80 Power Building
TENNESSEE VALLEY AUTHORITY
CHATTANOOGA, TENNESSEE 37401

September 20, 1976

Director of Nuclear Reactor Regulation
Attention: Mr. Voss A. Moore, Assistant Director
Environmental Projects
U.S. Nuclear Regulatory Commission
Washington, DC 20555

In the Matter of the Application of) Docket Nos. 50-390
Tennessee Valley Authority) 50-391

REV. NO.	ECN NO.	DATE	DESIGN	ISSUE	CHG.	APP.	REC'D	APP.	DATE
WATER USE DIAGRAM									
TENNESSEE VALLEY AUTHORITY DIVISION OF ENGINEERING DESIGN									
SUBMITTED			RECOMMENDED			APPROVED			
INSPECTED AND APPROVED FOR ISSUE									
KNOXVILLE

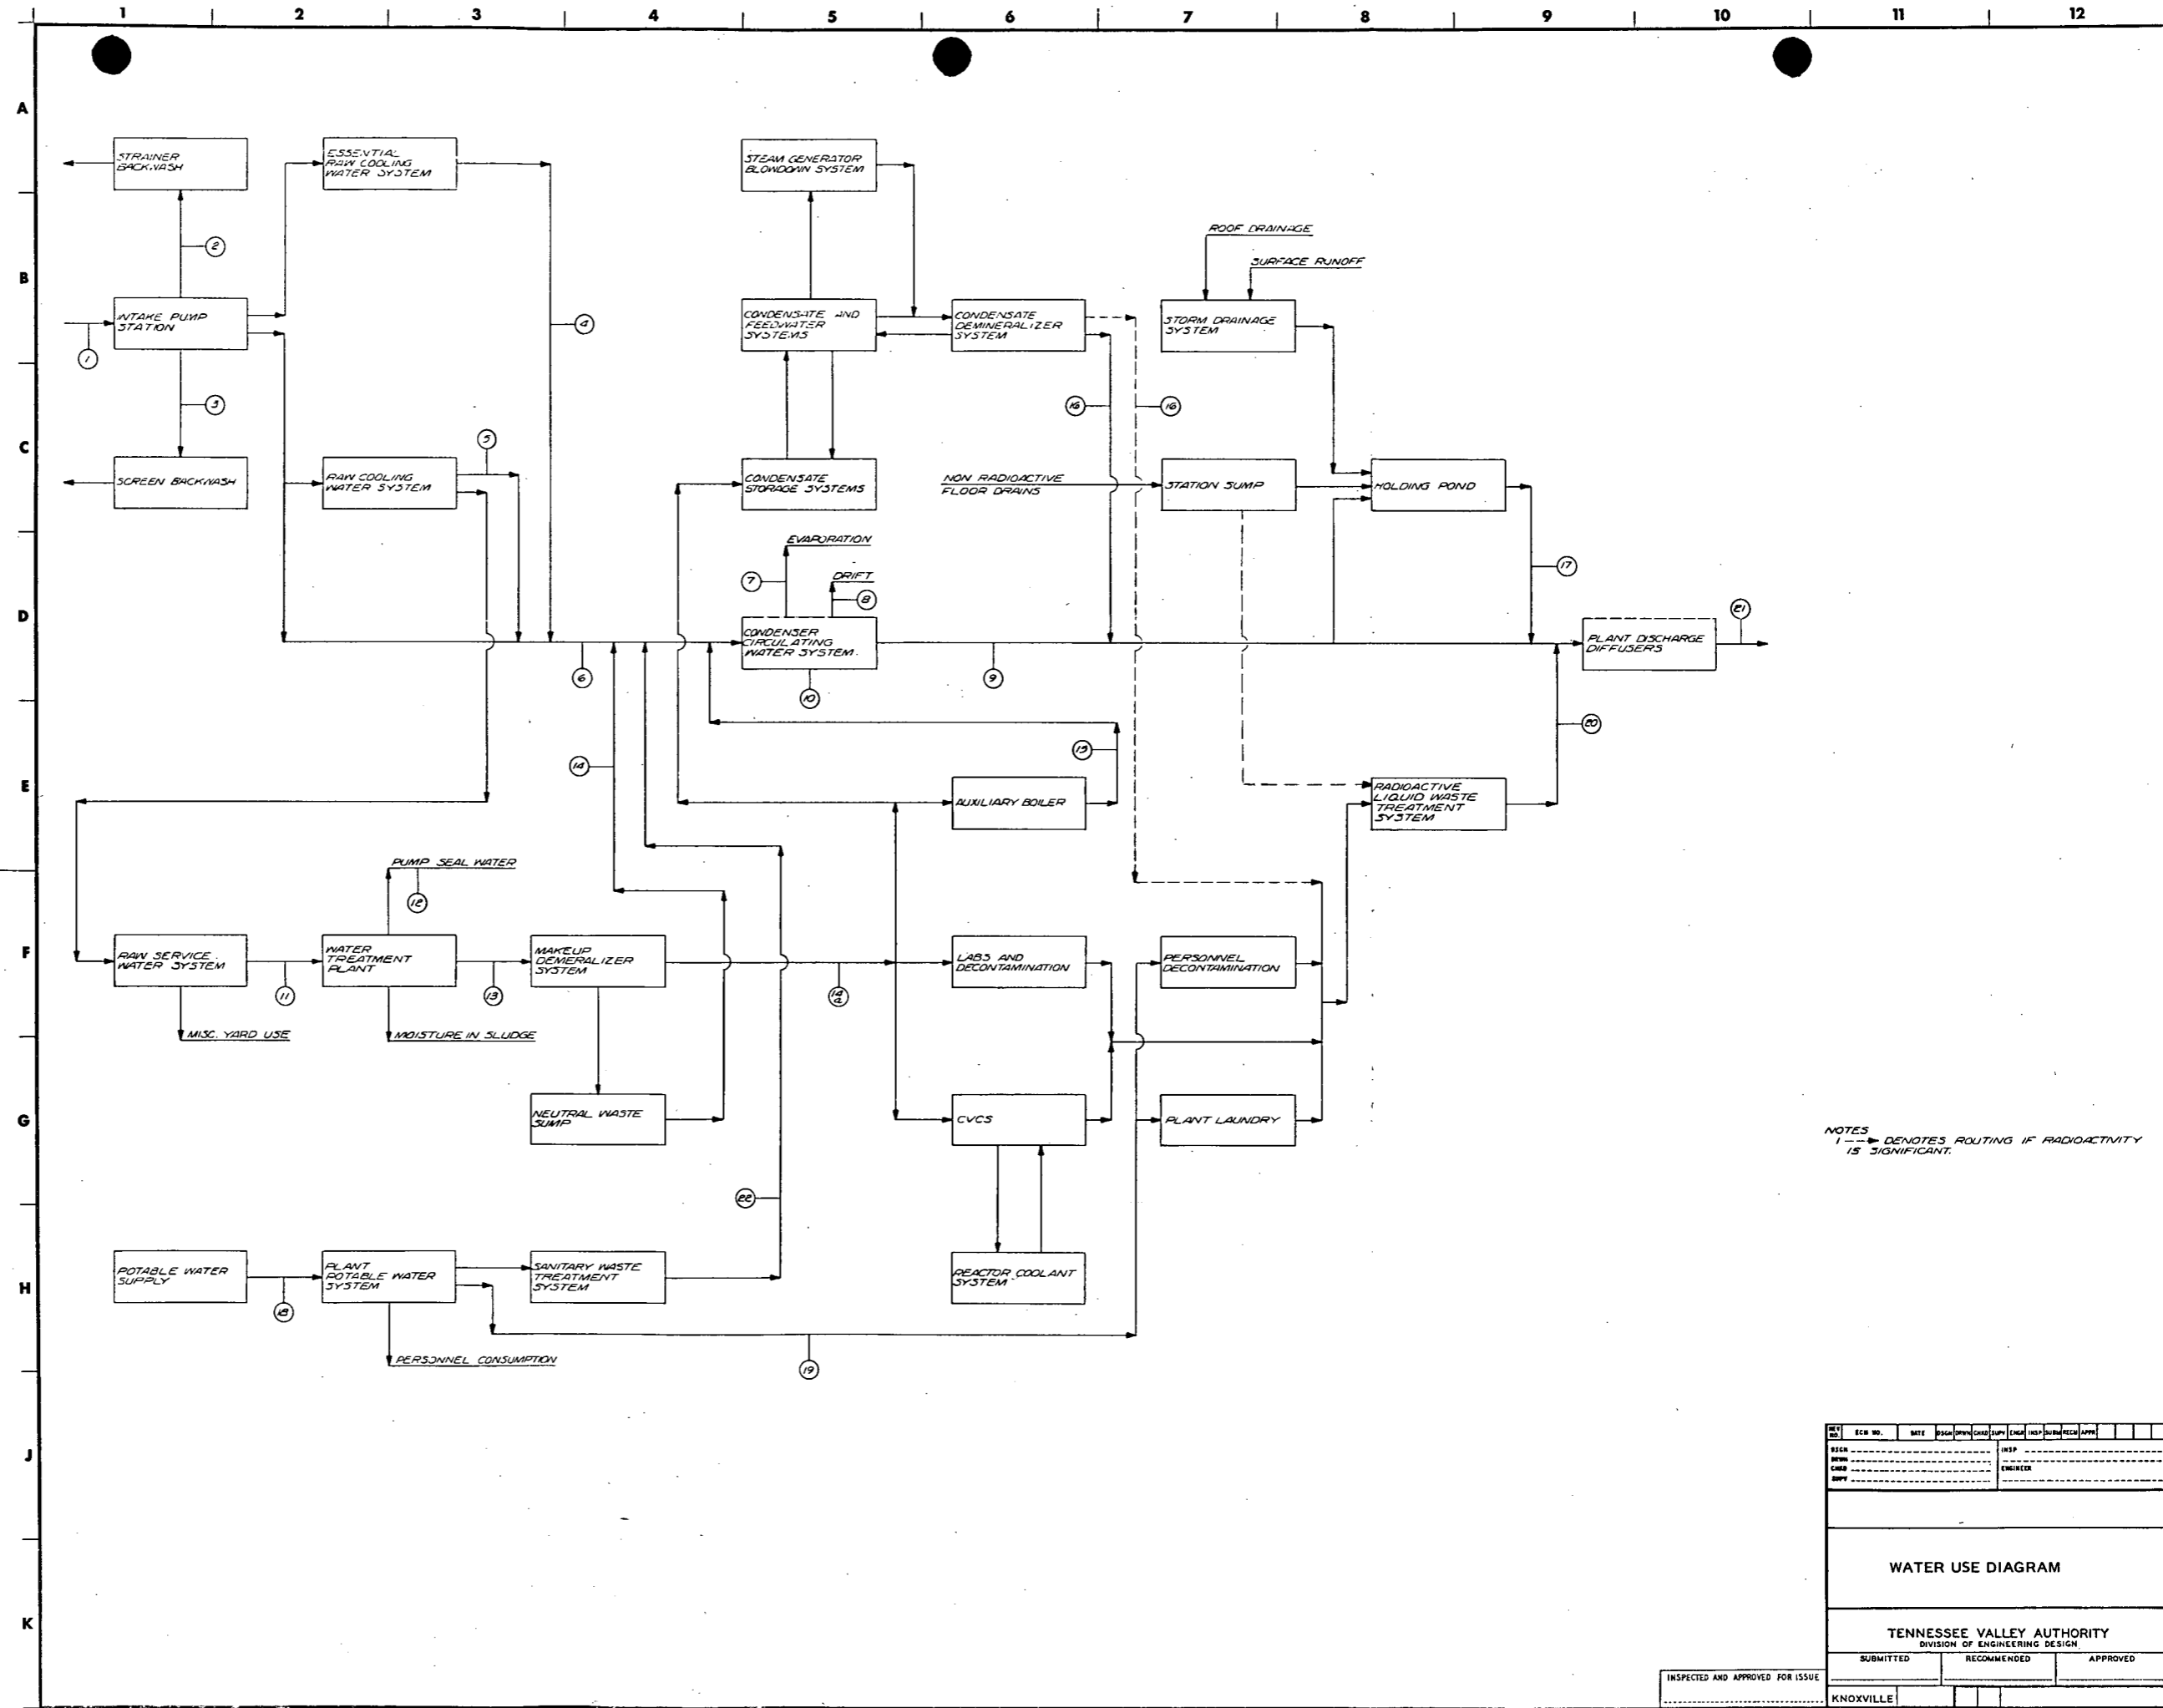
A.1. Provide quantitative water-use diagrams for the plant showing maximum and monthly average flow rates to and from the various plant water systems (heat dissipation system, sanitary system, radwaste and chemical waste systems, process water system, etc.) in support of liquid radionuclide release rate and concentration estimates.

Attached is a water-use diagram and a table giving the flow rates for the various indicated points on the drawing.

CONCRETE BLOWDOWN DIFFUSER PIPE OUTLINE & REINFORCEMENT

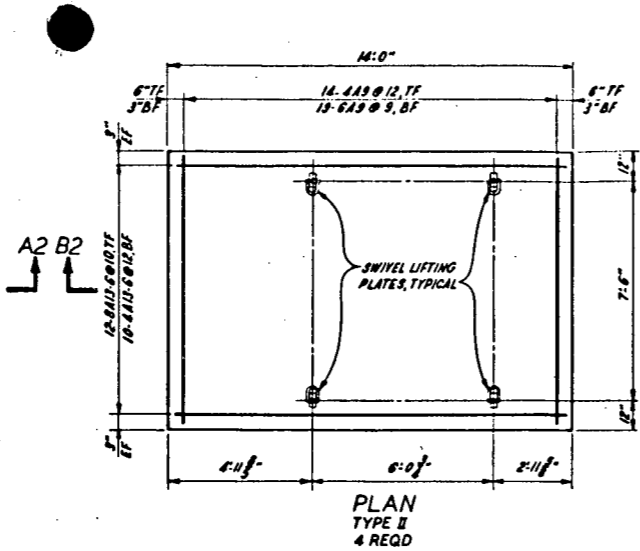
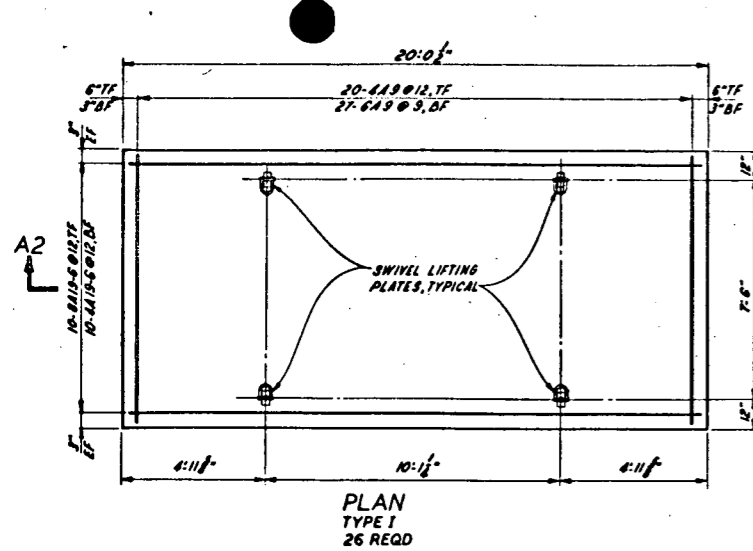
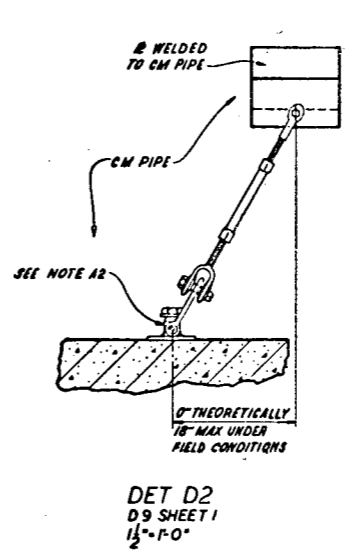
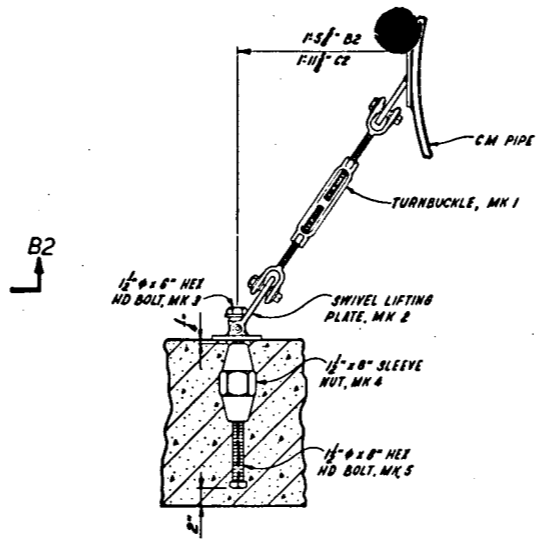
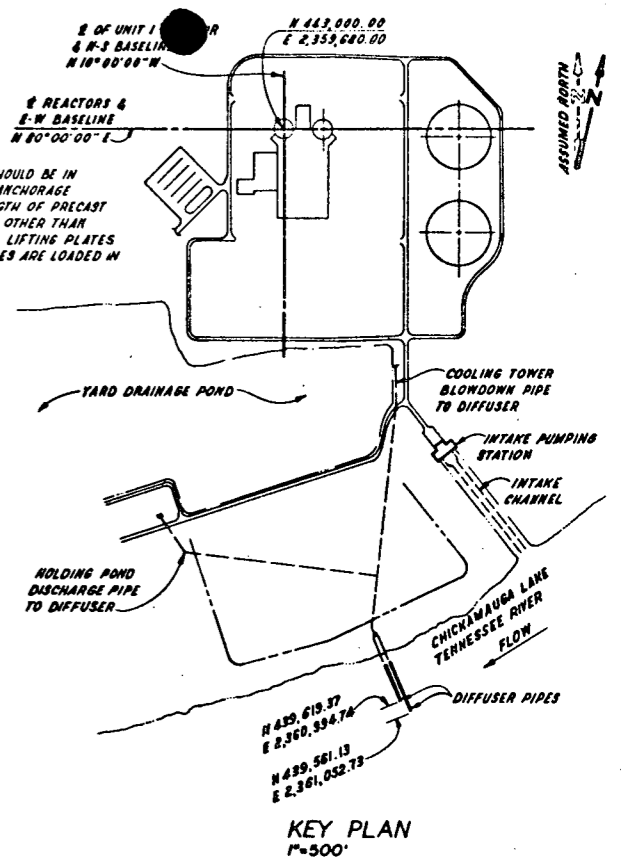
A.4. Provide a detailed description of the liquid discharge structure.
Identify any institutional restrictions (State or local) on releases.

The discharge structure at Watts Bar is a multiport diffuser system. The system will consist of two parallel conduits extending into the river. Attached are two drawings showing the diffuser layout.
